SERVICE INSTRUCTION

Introduction of a new clamp part no. 638140 for ROTAX 912 i Series

ATA System: 76-00-00 Engine control

Fig. 1

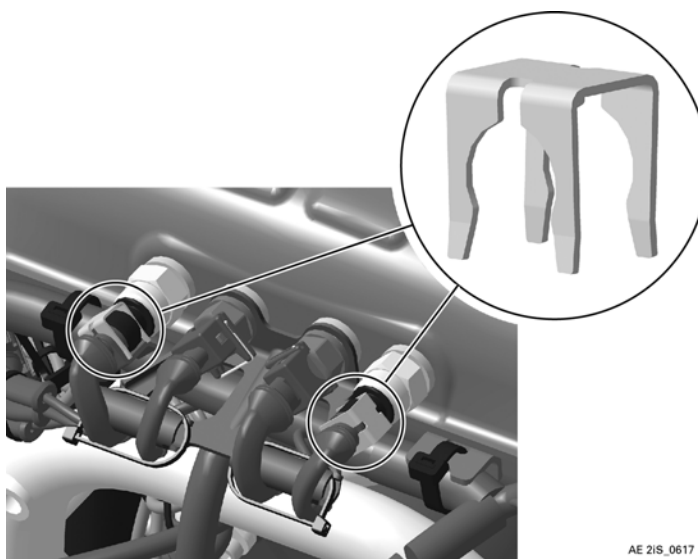
In the course of continuous development an additional clamp part no. 638140 has been introduced, which improves the connection and tight fit of the MAP sensors.

Step	Procedure
1	Check connector of MAP sensors for tight fit. NOTE: Make sure the connector latch shows vertically to the bottom.
2	Install the clamp as shown in figure 1. Check for tight fit and correct position of the clamp on sensor and connector. NOTE: To remove the clamp use a proper pair of pliers.

- Restore aircraft to original operating configuration.
- See latest Maintenance Manual (Line), maintenance checklist. The clamp itself needs to be visually checked and also checked for tight fit at least every 100 h of operation and/or at next maintenance event.
